Subject: AP1000 Response to Request for Additional Information (TR 85)

RAI-TR85-SEB1-10 R4

Response to Request for Additional Information on Technical Report No. 85

RAI Response Number: RAI-TR85-SEB1-10

**Figure RAI-TR85-SEB1-10-1 – Passive Pressure versus Deflection at Grade (North-South Excitation)**

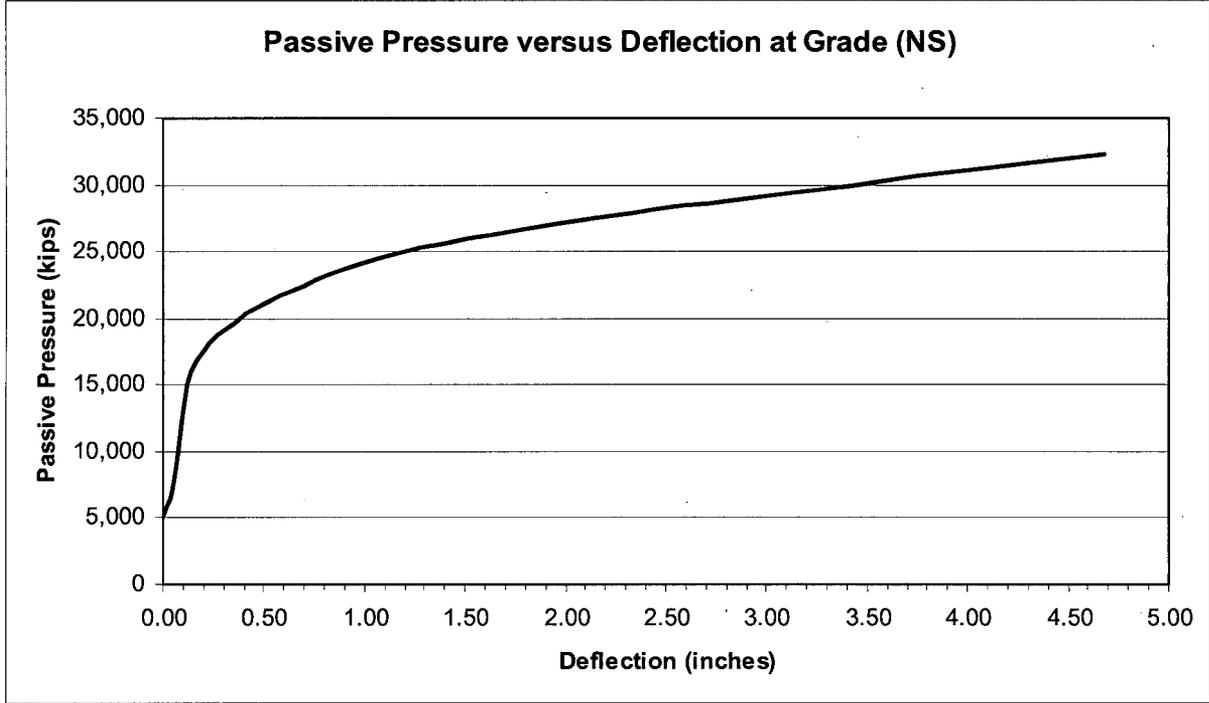
In the evaluation of sliding different coefficients of friction are considered. They are 0.7, 0.6, and 0.55. Also, it is necessary to rely on passive pressure. Using Case 15 (RAI-TR85-SEB1-35, R1, Table RAI-TR85-SEB1-35-1), and the methodology given in Reference 1 using a soil friction angle of  $35^\circ$ , a relationship between passive pressure and displacement at grade elevation can be defined. This relationship is shown in Figures RAI-TR85-SEB1-10-1 and RAI-TR85-SEB1-10-2 for the first 5 inches of deflection. Curves are given for the North-South and East-West directions. The passive pressure at zero deflection is equal to the at rest pressure. The total passive soil pressure resistance force is 43,500 kips for the North-South direction, and 69,100 kips for the East-West direction. It is noted that to achieve the full passive pressure displacements in excess of 10 inches are required.

Figure RAI-TR85-SEB1-10-3 - North-South FS without Passive Pressure

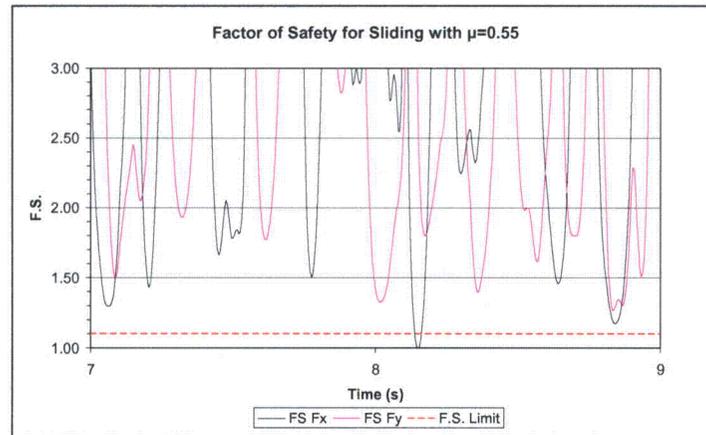
During the sliding stability calculation it was determined that the factor of safety for sliding drops below the limit of 1.1 for a very short time if passive pressure is not considered. Plots of the factor of safety (FS) versus time for the hard rock case and the North-South and East-West directions are given in Figures RAI-TR85-SEB1-10-3 and RAI-TR85-SEB1-10-4 using a coefficient of friction of 0.55. As seen from these figures the time at which the factor of safety drops below 1.1 is very short. This is the only time during the seismic event that this occurs. When the passive pressure is considered, the factor of safety remains above the limit of 1.1.
